LOCATION Alterations at Fraser Rd.
Underpass

Subject: FRASER ROAD UNDERPASS - ALTERATIONS
Highway 401
District 9 (Ottawa)
W.P. 60-75-01 Site 31-230

Subject: W.P. 60-75-01, Site 31-230
Alterations at Fraser Road Underpass
Highway 401, District 9-Ottawa

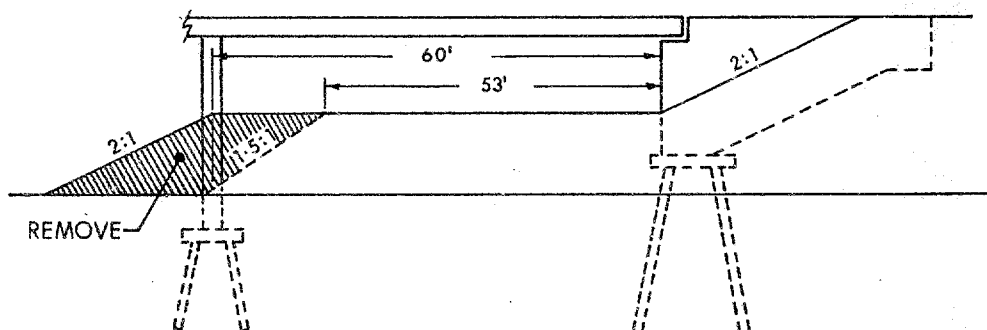
We have carried out analyses to investigate the stability of forward slopes with the revised geometry, as requested by you.

The proposal entails the construction of a 12 ft. lane under each end of the bridge. This would result in reducing the overall length of the forward slopes by 12 ft. This reduction in length would be achieved by making the forward of the berm 1.5 horizontal to 1 vertical, from the present slope of 2 horizontal to 1 vertical and by decreasing the length of berm to 53 ft. from the present 60 ft., as shown below.

The analysis shows that the slope as shown above has adequate factor of safety against failure.

GENERAL PLAN

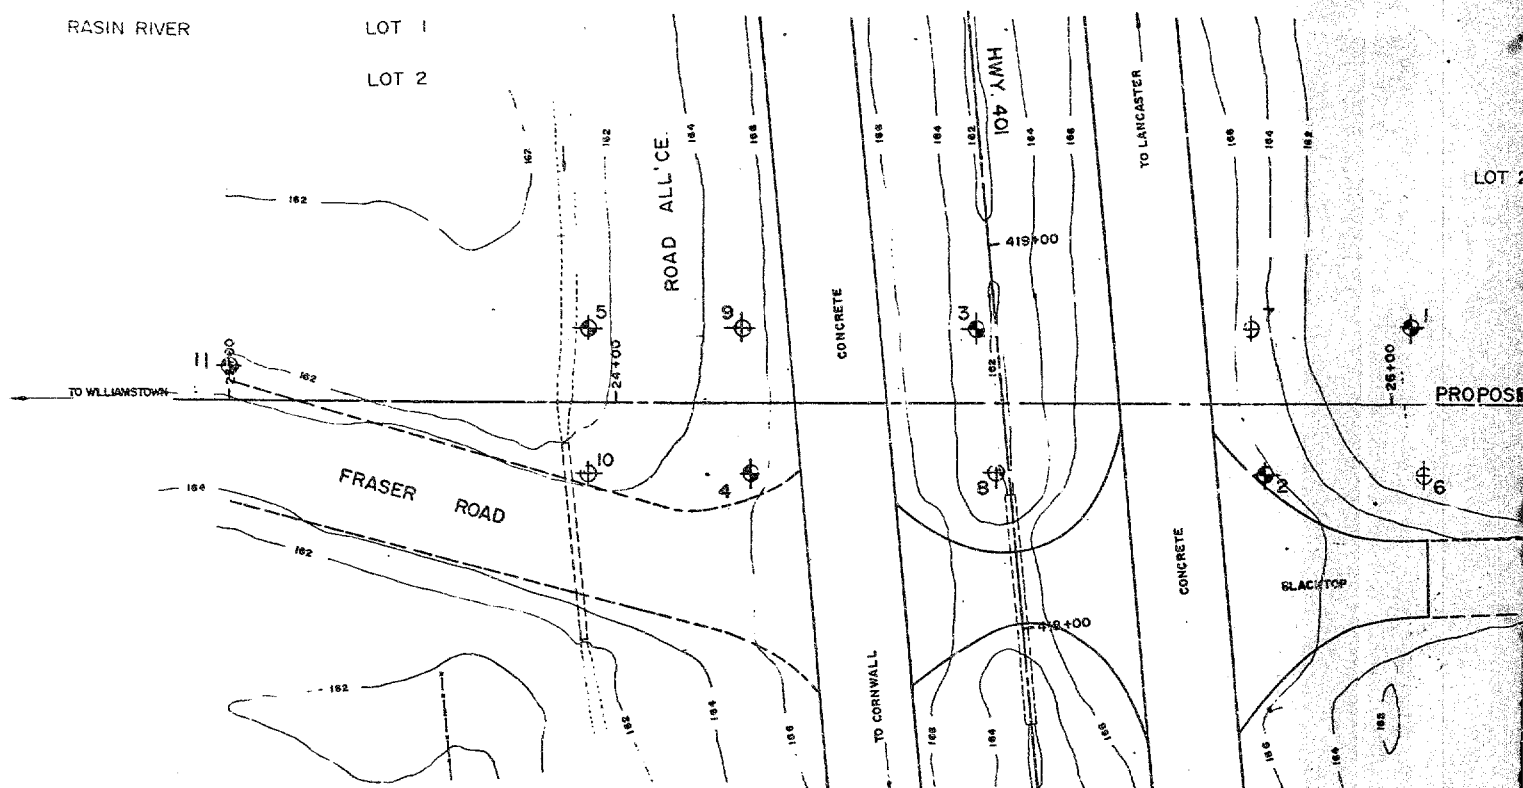
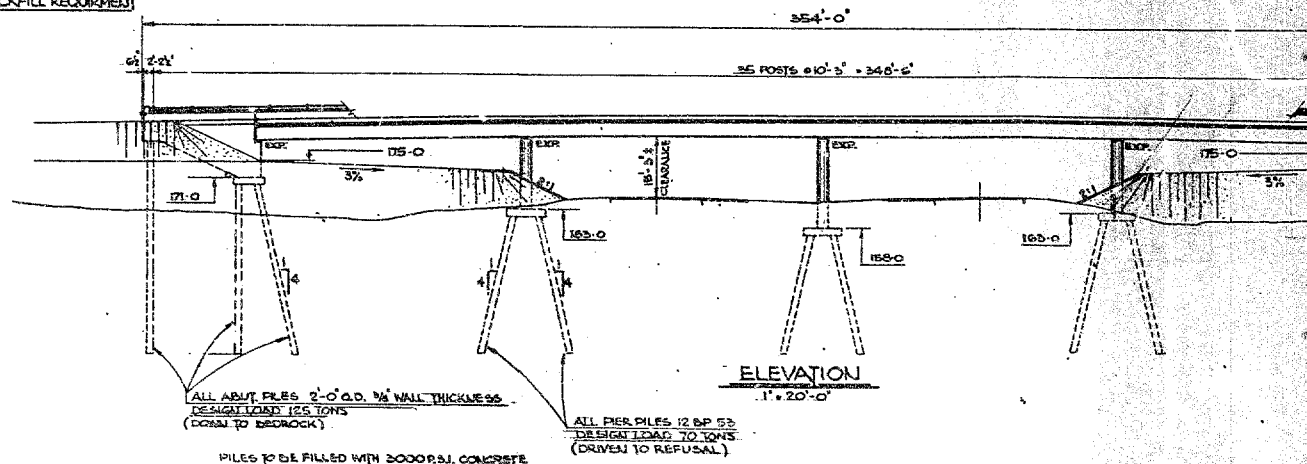
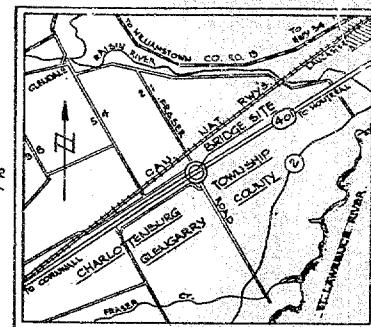
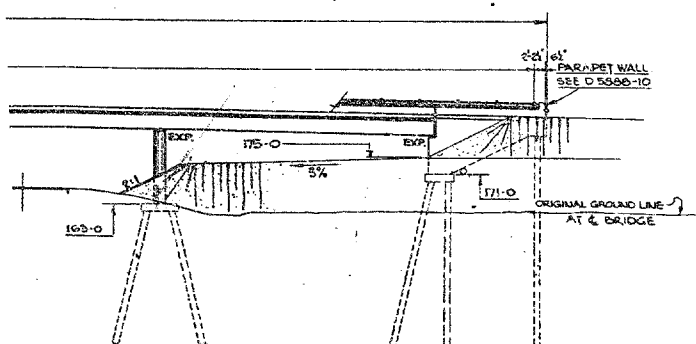
Further to our recent telephone discussion, I confirm that we shall be glad to receive your recommendations concerning the proposal to construct a **Parcel A Interchange** at the above structure. We are enclosing copy of General Plan for the structure drawing D-5888-1 and Boring Plan & Soil Stratigraphy Section drawing D-5888-2.

The proposal will entail the construction of a further 12 ft. lane under each end of the bridge. A minimum widening at each end of 12 ft. is envisaged.

Your views are sought as to the advisability of removing part of the north and south longitudinal berms under the structure in order to accommodate the proposed extra lanes. The existing berms are approximately 80 ft. in length in the longitudinal direction.

If stability considerations preclude partial removal of the berms without alternative support being provided, we shall be glad to receive your views on alternatives, such as sheet piling, or excavating part of the sensitive clay layer and replacing it with suitable material.
